Recall Bulletin

File In Section: Product Recalls
Bulletin No.: 04027
Date: May 2004

SUBJECT: DRIVER'S SAFETY BELT ANCHORAGE

MODELS: 2004 CHEVROLET MALIBU AND MALIBU MAXX

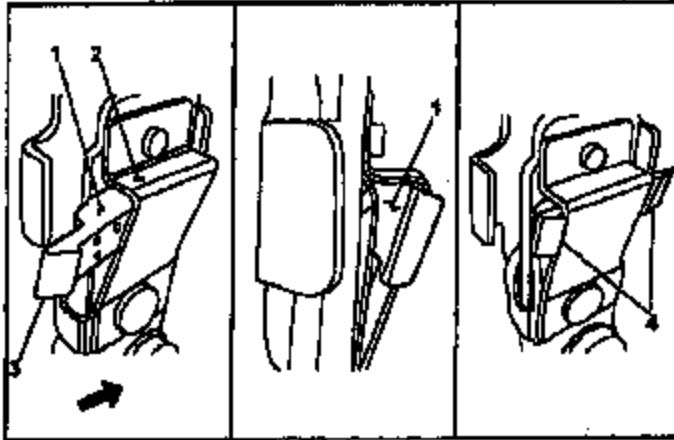
To prevent the possibility of this occurring, dealers are to install a retainer in the front safety belt connectors.

The following procedure provides instructions for installing a plastic retainer in the seat belt connector on both the driver and front seat passenger seat belt lower webbing attachment point.

1. Open the driver's door and locate the seat belt webbing (3) lower attachment point (2) directly below and inboard of the seat recliner handle (1).
2. Raise the seat recliner handle to access the opening in the seat belt connector (4).

Visually inspect the retainer (3) and note the taper on the backside. The wider portion of the retainer (1) must be at the top (2) of the seat belt connector when installing.

3. Using long nose pliers, install one plastic retainer in the opening in the seat belt connector as shown.
 - o When properly installed, the wider portion of the retainer (1) will be at the top and a snap type sound will be heard when the locking feature (4) on each end of the retainer engage the edges of the seat belt connector.
4. Repeat this procedure on the right front passenger seat belt connector.
